UNITED STATES PATENT AND TRADEMARK OFFICE

10/534,178

Office Action Summary	Application No. 10/534,178	Applicant(s) BECK, JOSEF	
	Examiner DNYANESH KASTURE	Art Unit 3746

DETAILED ACTION

FIG. 2

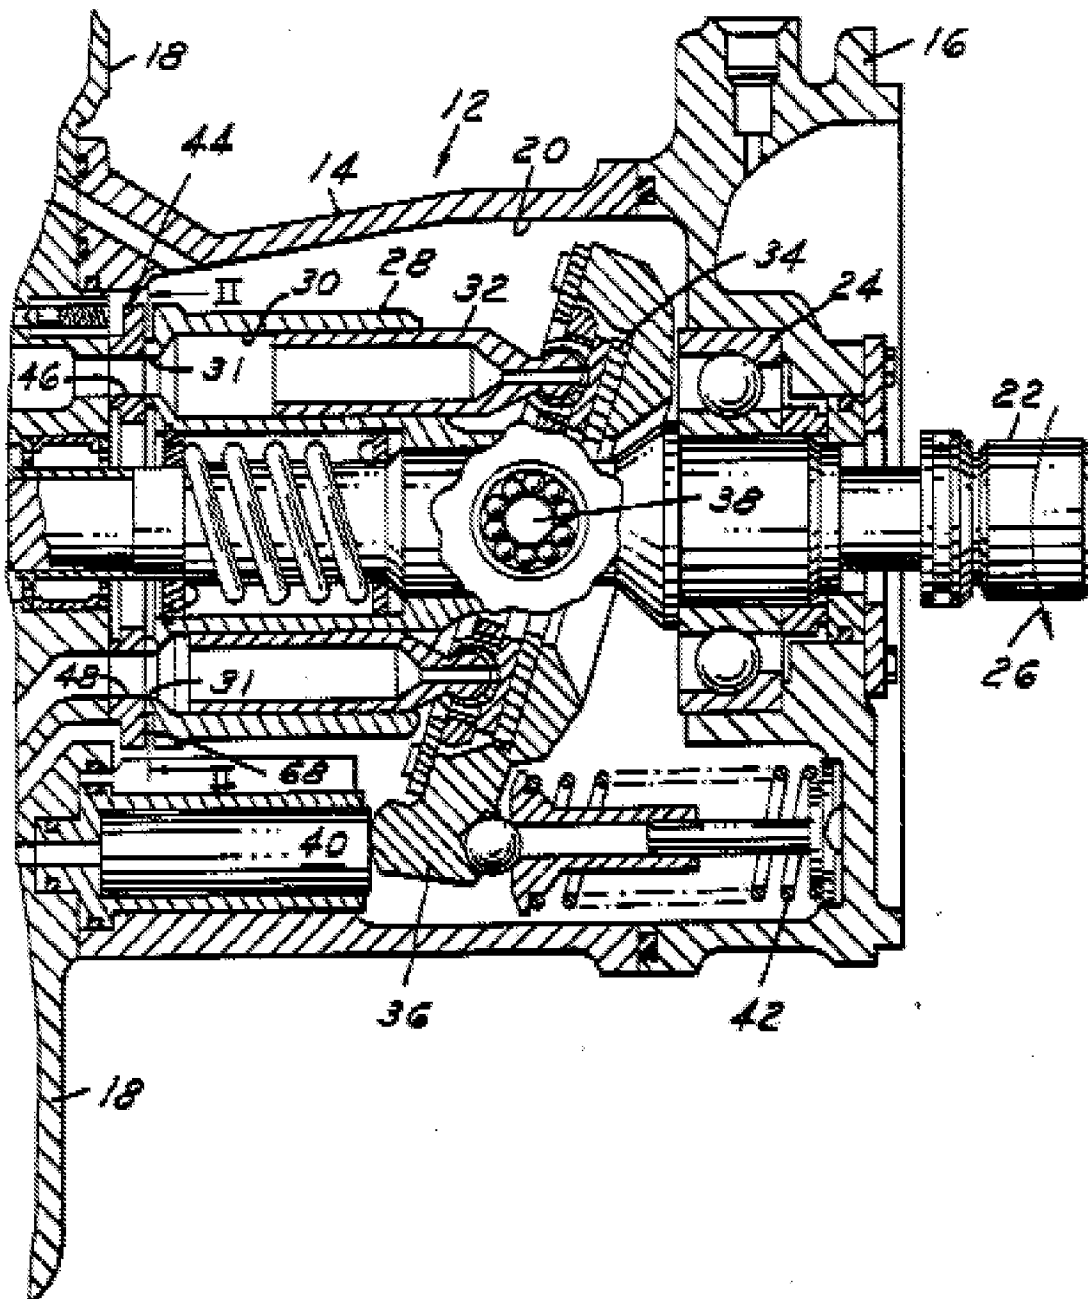
8. In Re claim 1, with reference to figures 1B and 2 depicted above, Tovey discloses a control plate (44) for an axial piston machine (12) having at least two control openings (46), (48) by means of which cylinder bores (30) of a cylinder drum (28) rotatably mounted (on shaft (22)) in housing (14) are alternately connected, on rotation of the cylinder drum (28), to a high pressure connection (48) and a low pressure connection (46) a through opening (66) formed in the control plate wherein:

- the radially inner edge (depicted by label 66 pointer) of the control plate (44) is designed as a centering surface around shaft (22)
- the centering surface comprising plurality (2) of partial surfaces formed on segments (depicted above in Figure 2) of the inner edge of the control plate (44) which extend radially inward into the through opening (66) as depicted in Figure 2, and are separated by recesses as depicted
- both recesses are next to the centering surface (see figures in the "Response to arguments" section) and are capable of receiving a locking element.

9. In Re claim 3, Figure 2 of Tovey depicts the thickness of the segments is substantially the same as the depth of the recesses, and they also have a finite width. The recess transforms into a gap between the shaft (22) and the radially inner edge (depicted by label 66 pointer) after assembly of the machine.

10. In Re claim 4 and 12, Figure 1B of Tovey depicts a radial edge (lip that is pointed to by the arrow associated with label (44)). The lip surrounds the plate around the outer

edge and therefore is connected to the high-pressure connection and the low-pressure connection in the region of all the control openings.

11. In Re claim 6, Figure 2 of Tovey depicts the thickness of the segment is less than the thickness of majority of the plate.

12. In Re claim 7, Figure 2 of Tovey discloses kidney shaped control openings.

15. In Re claim 11, the radial extend of the recess is greater than the radial extend of the segment as depicted in Figure 2 of Tovey.

17. In Re claim 14, Tovey depicts the disc shape of the control plate in Figure 2, therefore the end side of the cylinder drum would also have to be disc shaped because the end side of the cylinder makes full surface contact with the control plate.

FIG. 1

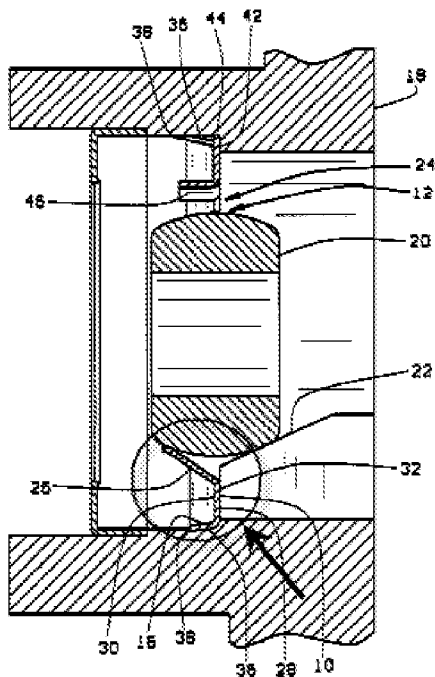
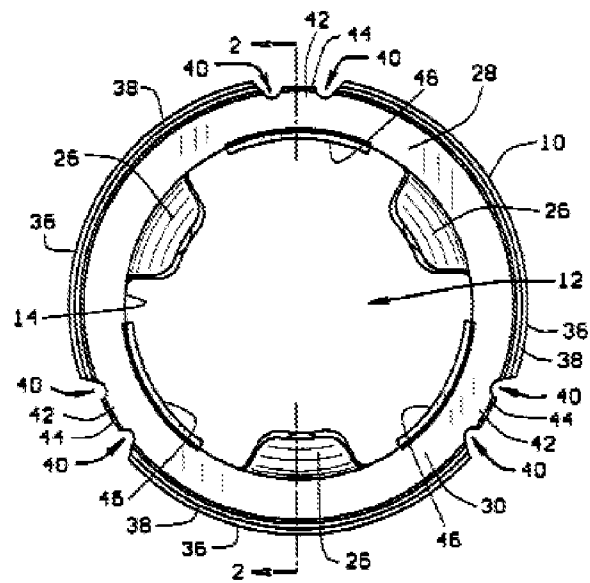
24. Nevertheless, Borcharding et al discloses a control plate (32) which seats against the surface (14) of the housing cover. The plate having radial inner edges (26) with a surface that is a centering surface as stated in Column 1, Line 11: "...plurality of radially extending tabs centered in gaps in the peripheral edge". The inner edges (26) abut against a bearing (20) that is on the housing seat (22).

25. It would have been obvious to a person having ordinary skill in the art at the time of the invention to modify the port plate assembly of Tovey to incorporate the bearing (on the housing seat) into the central opening in the control plate that surrounds the shaft (the bearing could be the element surrounding the shaft that is not part of the control plate) where the radially inner edge abuts the bearing as taught by Borcharding et al as a suitable design choice that supports a rotating shaft as stated in Column 1, Line 25 of Borcharding et al.

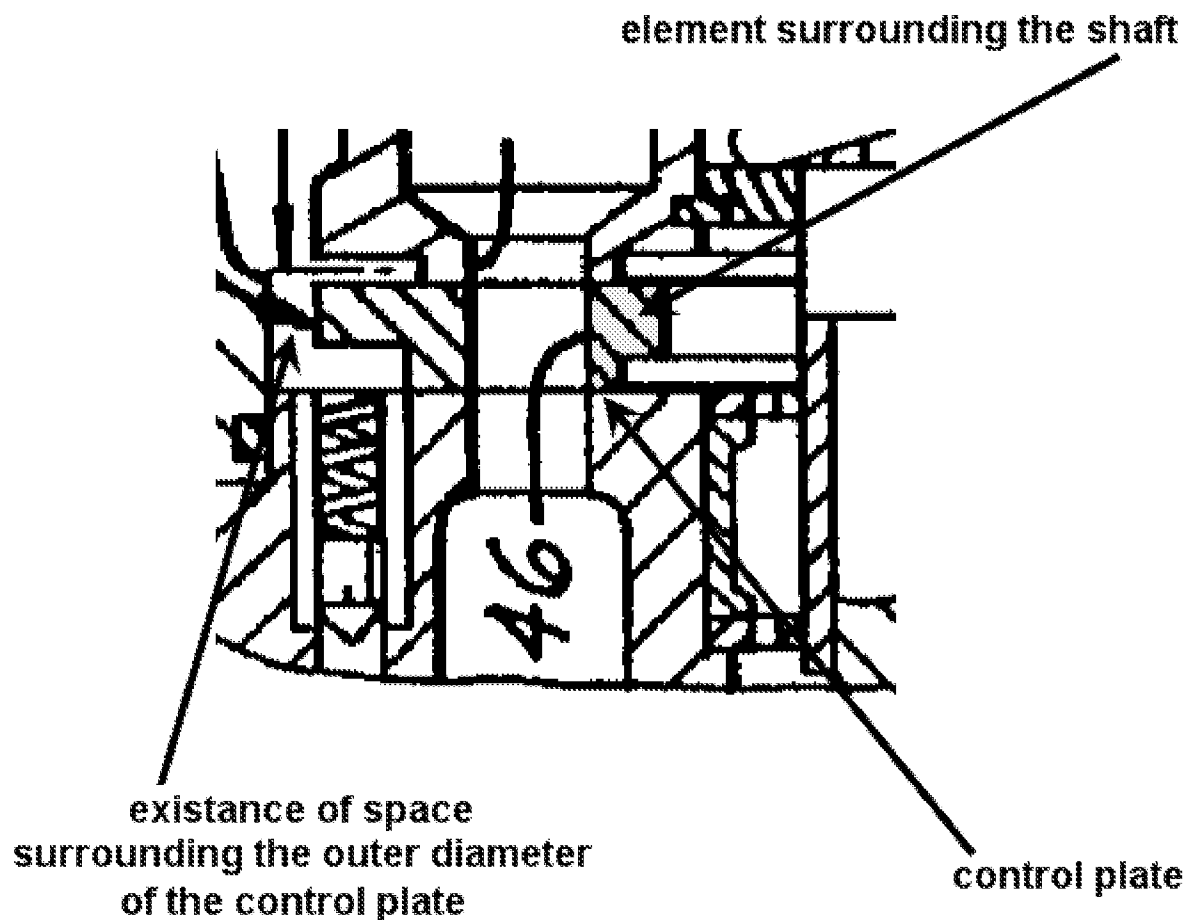
- Figure 2 of Tovey is a cross section of the apparatus, and the centering surface is perpendicular to the plane of this cross section which is why it is not visible in this view even though the radially inner edge is visible. Figure 2 of Tovey has been additionally annotated below.

Note the arcuate projection of the centering surface between ends of the two label lines, once again the centering surface is perpendicular to the plane of the figure. The shaded part of the figure is a protrusion that is part of the control plate.

- Tovey discloses at least 2 partial surfaces, one of which is annotated above on segment 2, the other is symmetrically on the opposite segment 1.
- With reference to the element surrounding the shaft not being part of the control plate, see annotated blowup of Figure 1B below.

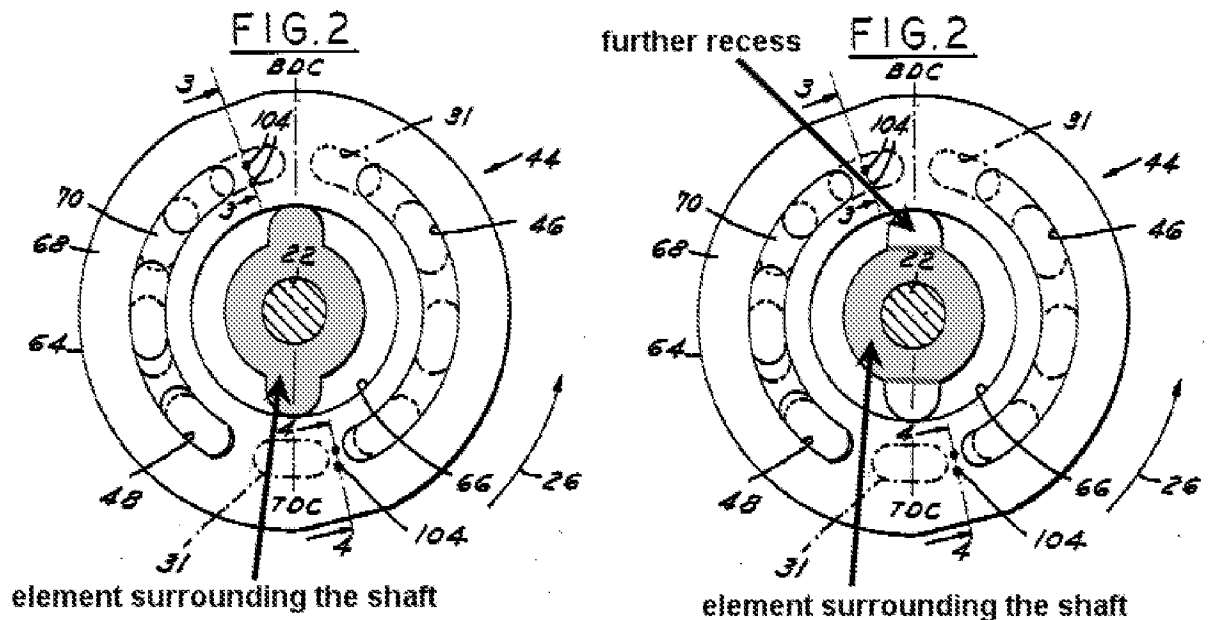
As seen by the crossing section lines, the element surrounding the shaft is part of the control plate and therefore there is no "separate" member interconnecting the control plate with a centering body.

The element surrounding the shaft (which mates with the centering surface) probably is separate from the shaft and looks like one of the two configurations depicted below by the shaded portion:

In the Figure on the left, the element surrounding the shaft would have to be fixed to the housing otherwise the projections will make the control plate rotate. In the Figure on the right, there is a further recess (at the centering surface) to receive a separate locking element.

- The above blowup depiction of Figure 1B also suggests that due to the existence of the gap around the outside diameter of the control plate, the control plate is not centered at its outer circumference.
